**Comments on PJM & ITRON  
Load Forecasting Recommendations  
*Draft***

**Date: 12/6/2010**

Figure 29: Weighted Economic Variable (Commonwealth Edison)

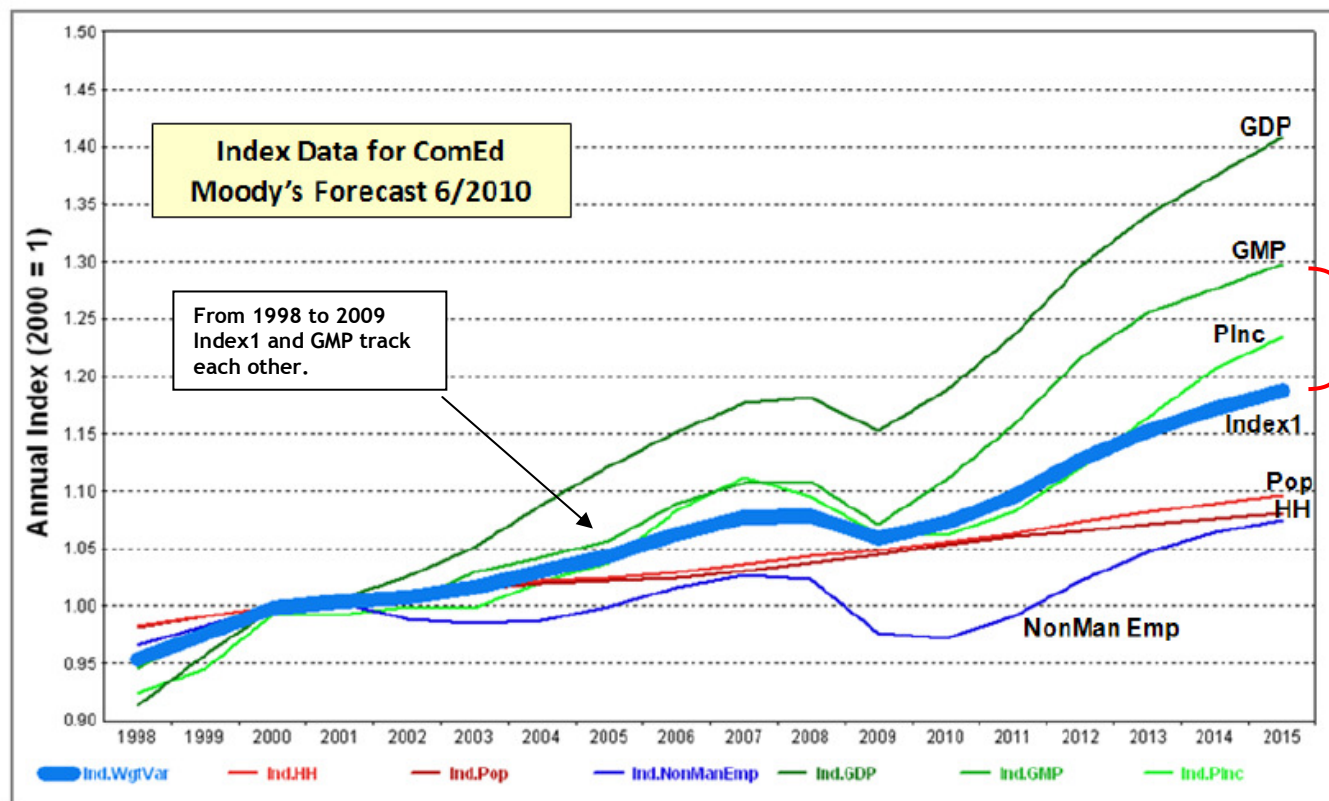
# Index1 has a systematic downward bias because the higher weights are assigned slower growth variables

Load changes are much more sensitive to GMP and GDP than to other variables.

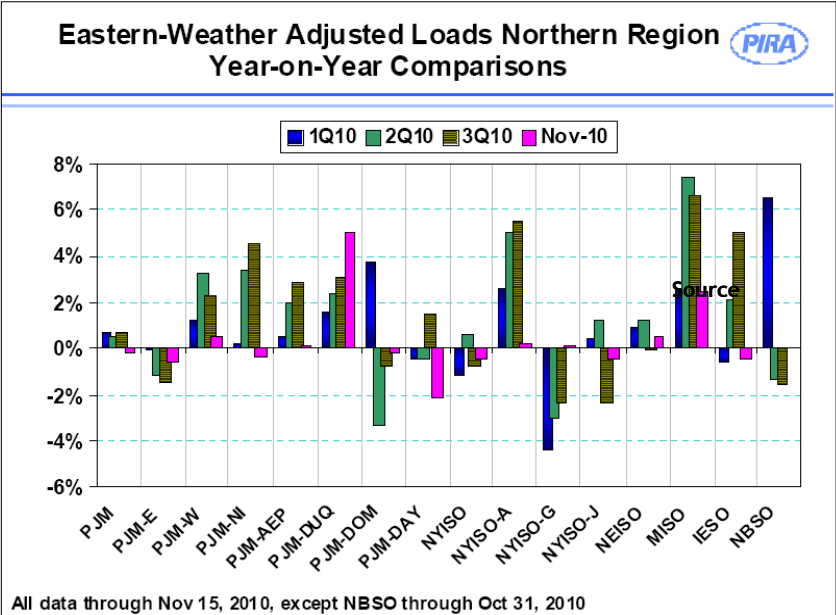
- Based on PIRA estimates, the changes have been above 4% for Commonwealth Edison during Q3-2010.
- Weather-adjusted load changes are much larger than those predicted by Index1. (see chart top right)
- Load changes are much more sensitive to Gross Metropolitan Product and GDP than to other variables.

Actual load follows GMP more closely than Index1 during 2009 & 2010

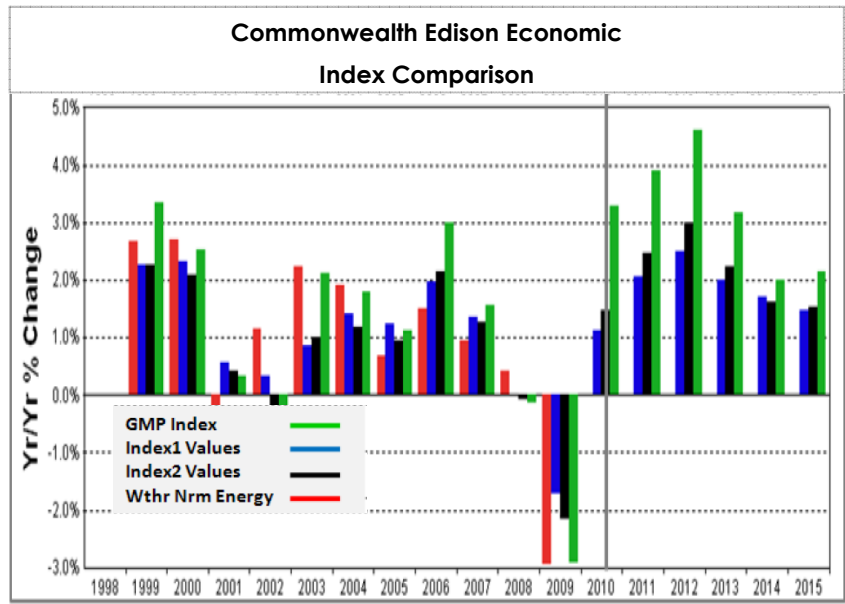
- GMP Model captures the large downward and upward year-on-year load changes in 2009 and 2010, respectively.
- Population and households have low and steady growth rate, so Index1 reduces load growth relative to GMP.
- The weights for population, household and non-manufacturing employment should be lower versus GMP & GDP.
